SUBJECT: REQUESTS SCHEDULE CHANGE IN TWO-UNIT THERMAL PLUME MAPPINGS  
 TO JUNE 1979.ALSO INFORMS NRC OF PROPOSED MOD TO DISCHARGE  
 STRUCTURE SCOUR BED TO ALLEVIATE EROSION PROBLEMS.TWO  
 OVERSIZED STRUCIURAL DRAWINGS ENCL.

Donald C. Cook Nuclear Plant Units 1 and 2  
Docket Nos. 50-315 and 50-316  
License Nos. DPR-58 and DPR-74  
Appendix B Technical Specifications

UNIT NO.1 DISCHARGE STRUCTURE  
SITE DEVELOPMENT PLAN & SECTIONS  
DONALD C. COOK NUCLEAR PLANT  
INDIANA & MICHIGAN ELECTRIC CO.  
BRIDGMAN, MICHIGAN

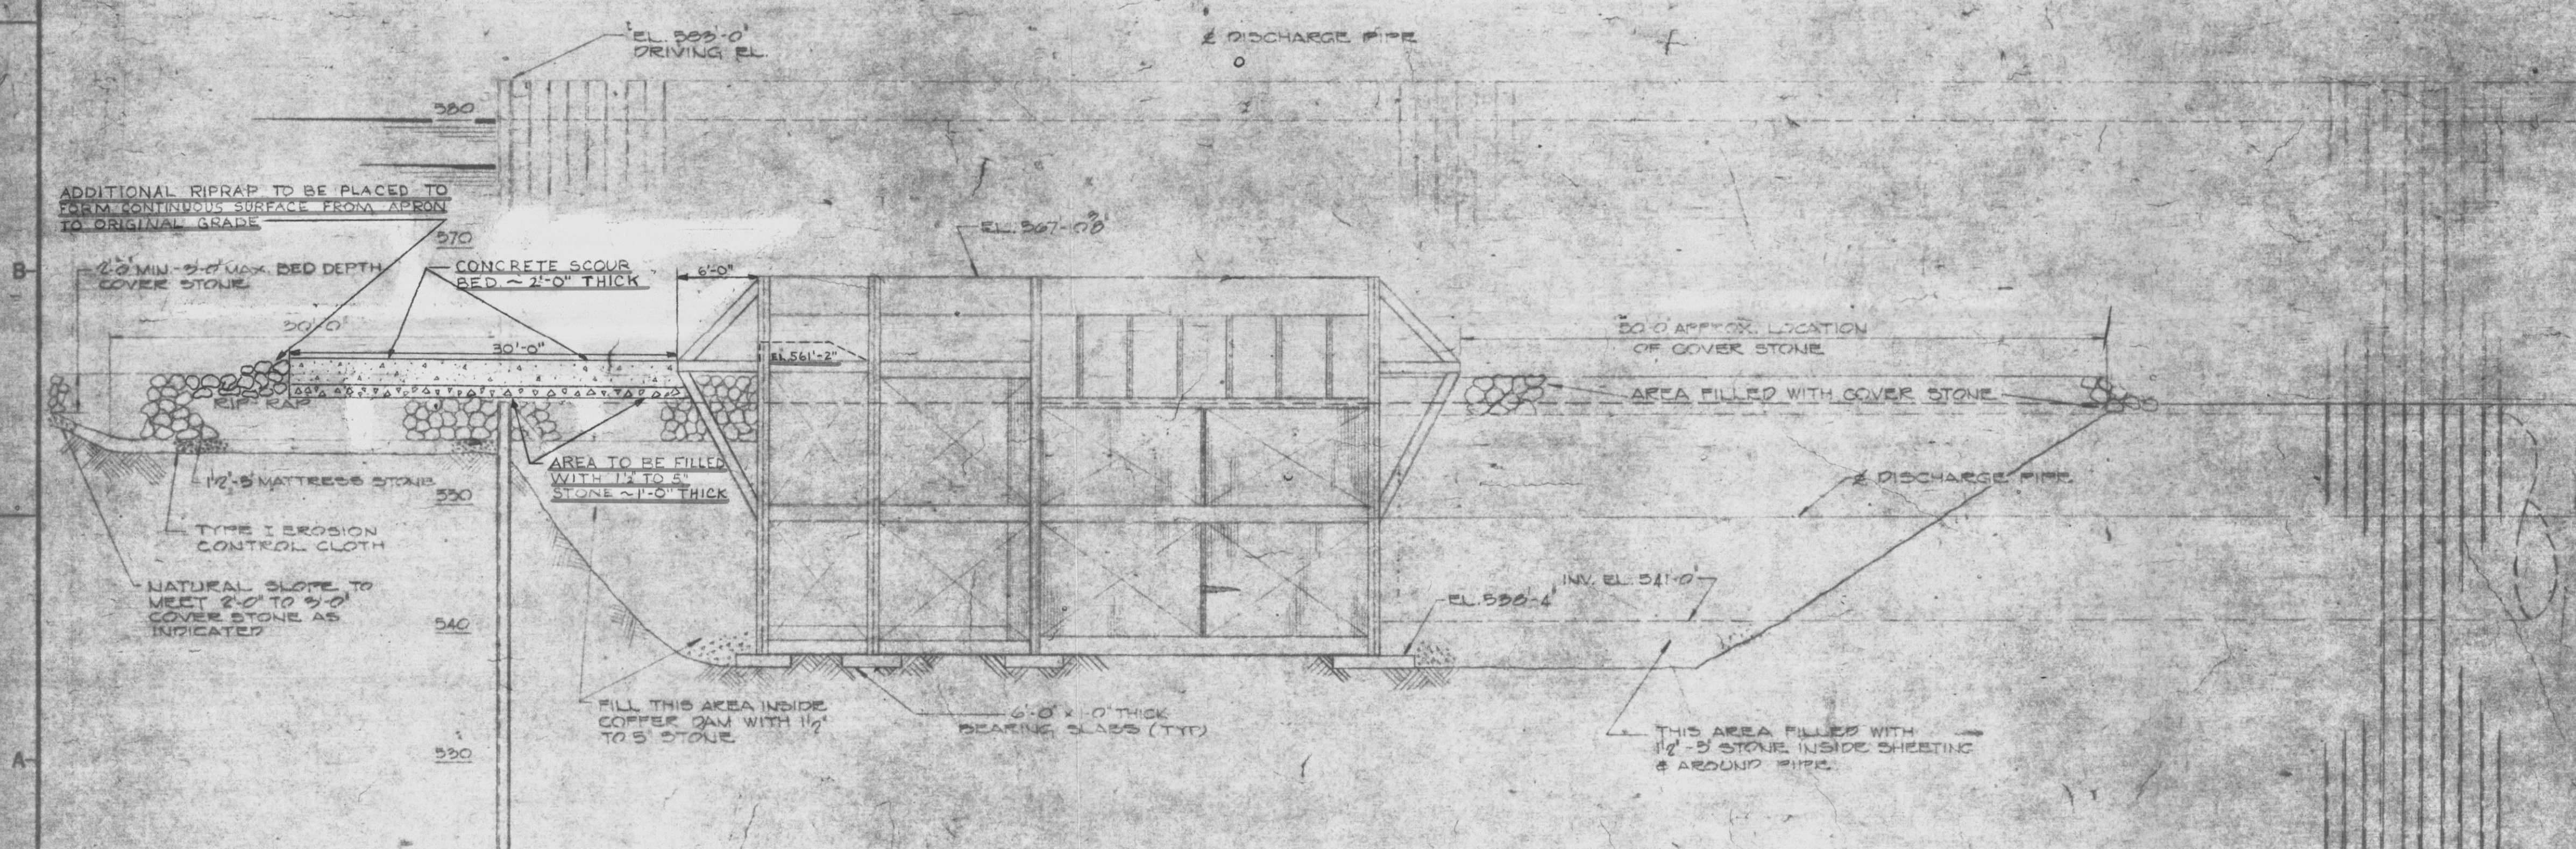
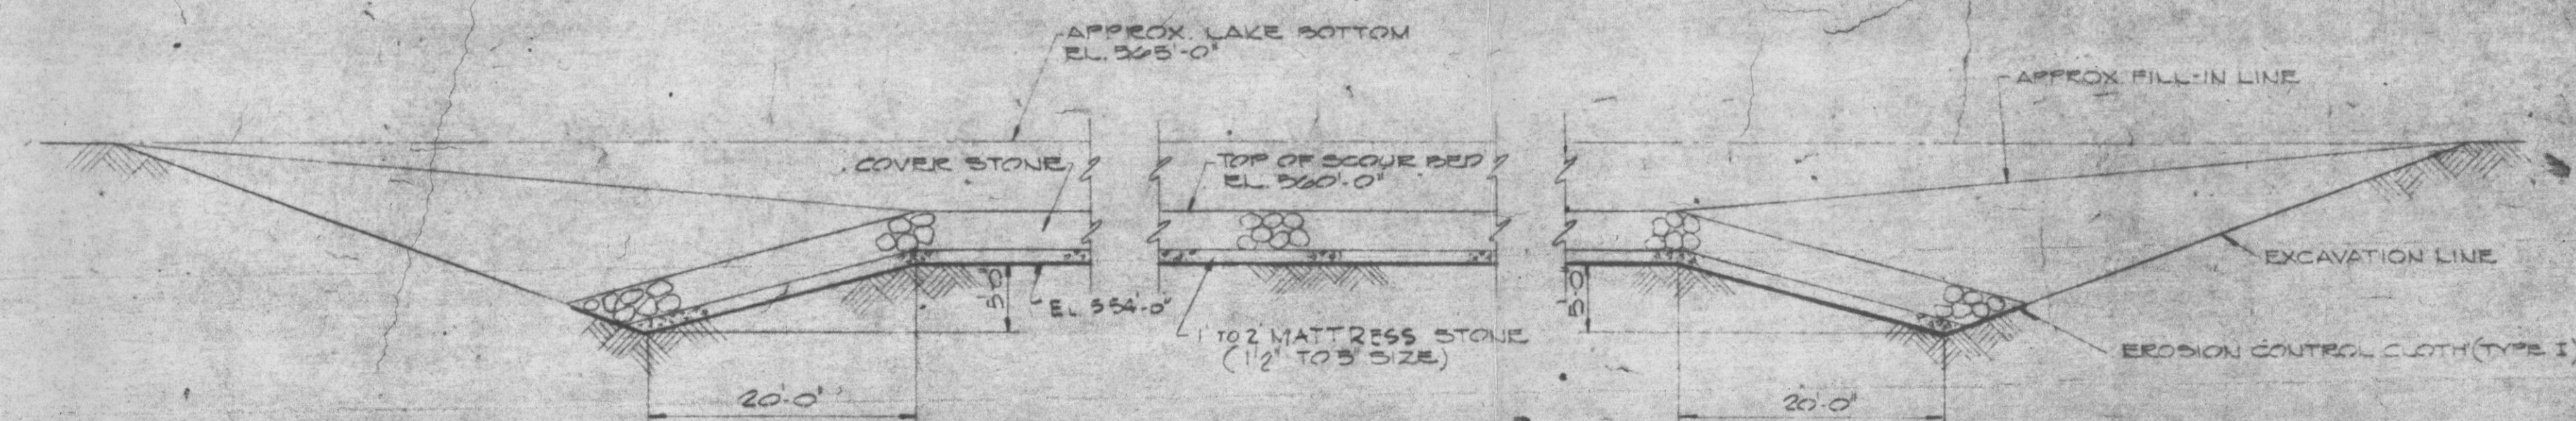
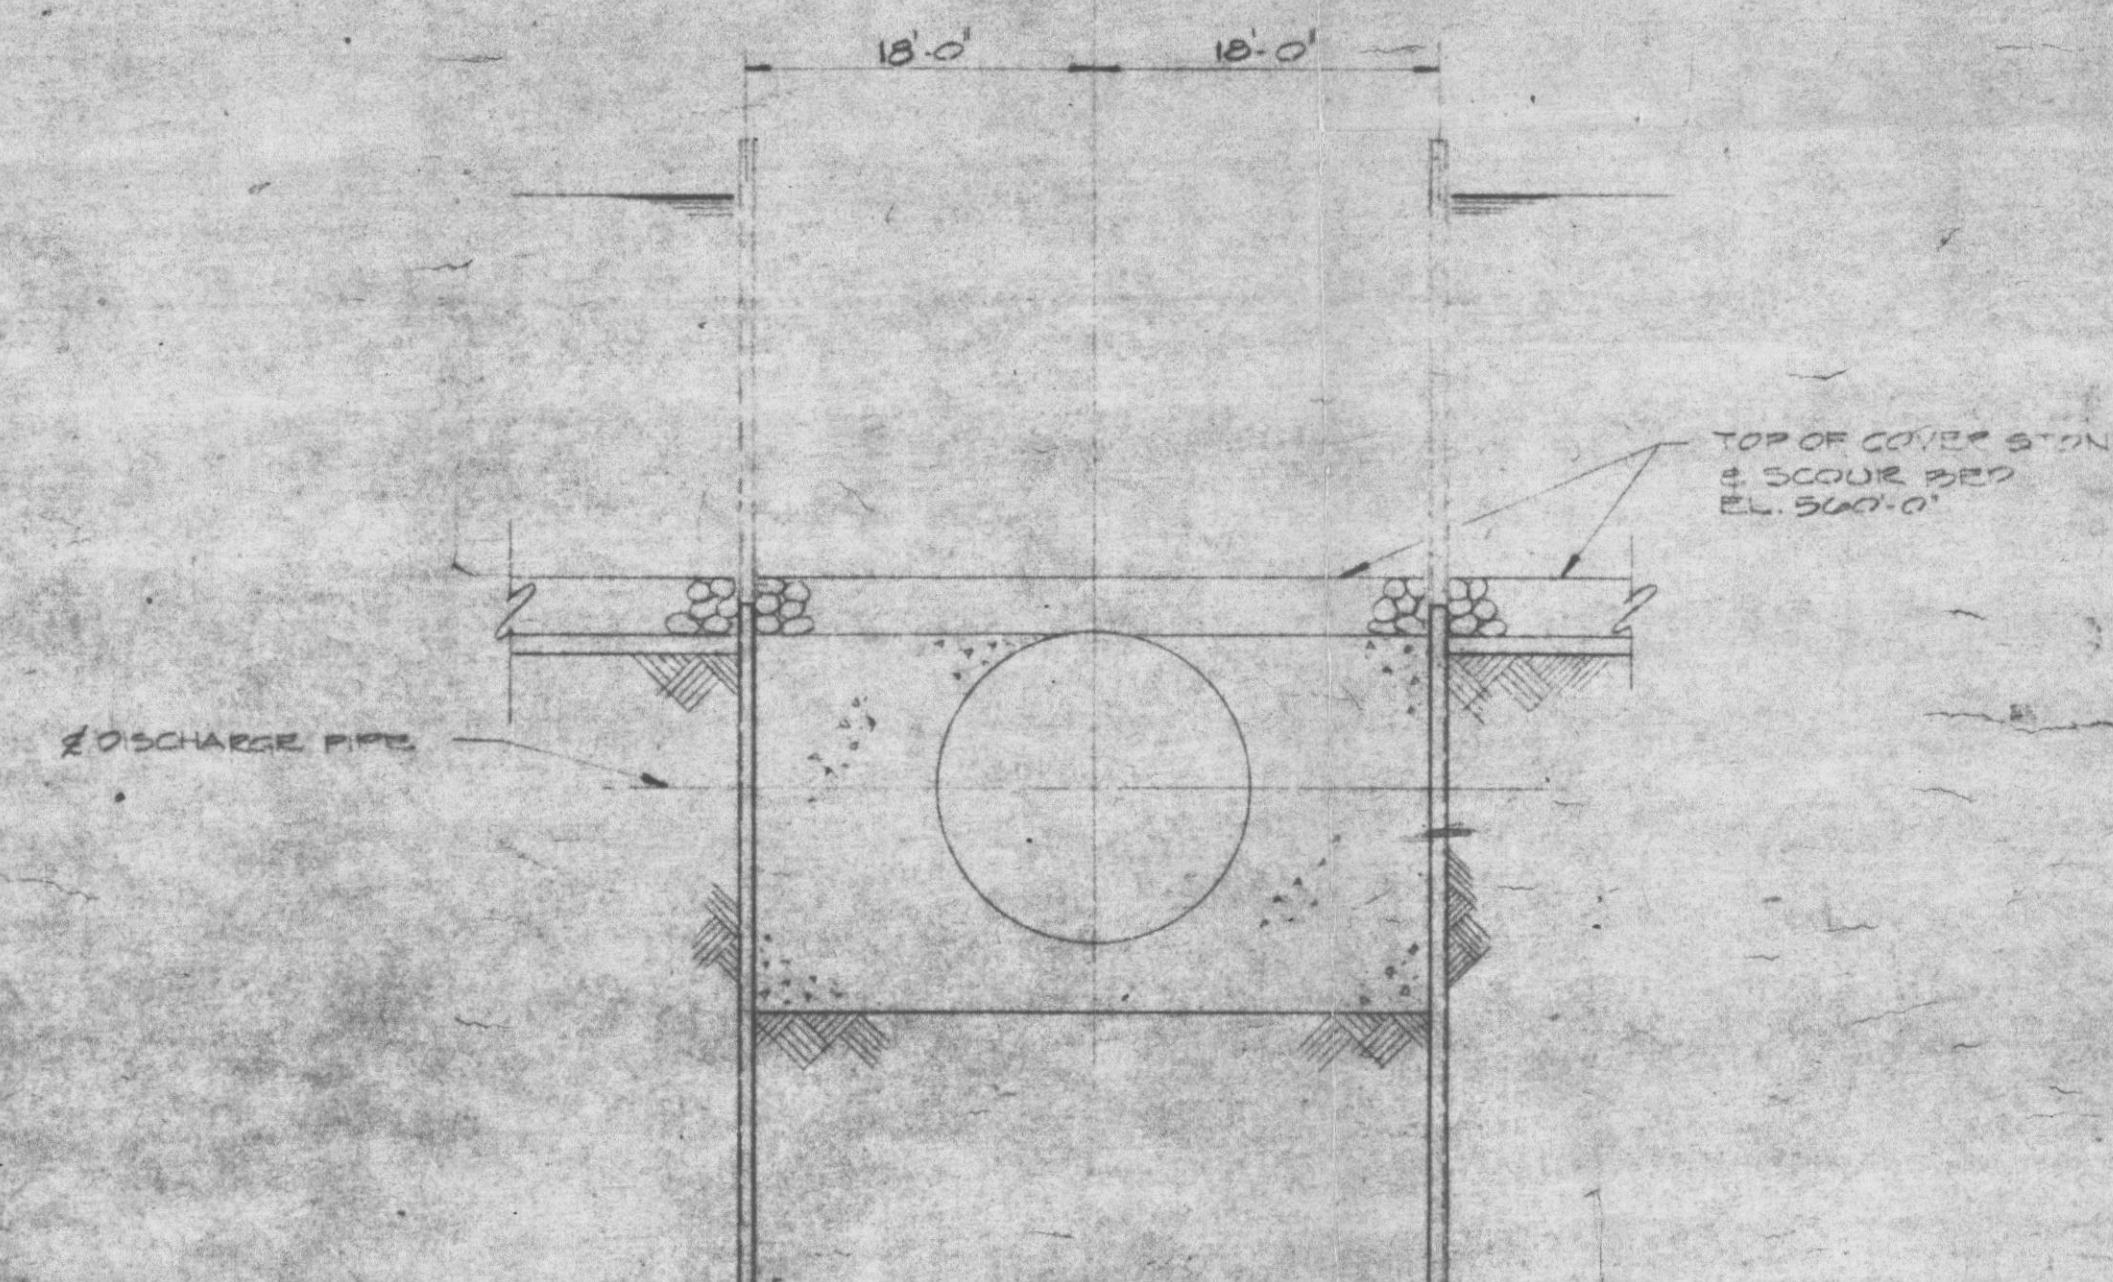
The problem encountered is twofold and stems from the need to have a high velocity for mixing the outflow with the ambient water. The approximate average exit velocity is 13 feet per second at the nozzles. The first aspect of the problem is that as the water exits the structure it entrains the surrounding water and sets it into motion. This motion can cause movement among the neighboring stones. Secondly, as the water exits the structure, it is affected by the presence of wave action. As a zone of local high pressure passes over the nozzles, it deflects the jet downwards to form a trench in the scour bed. The riprap then piles up and deflects the jet upwards to the surface of the lake where disturbance of the surface water is visible. The plan and section of the present conditions are shown on Drawing No. 12-3721-6, attached.
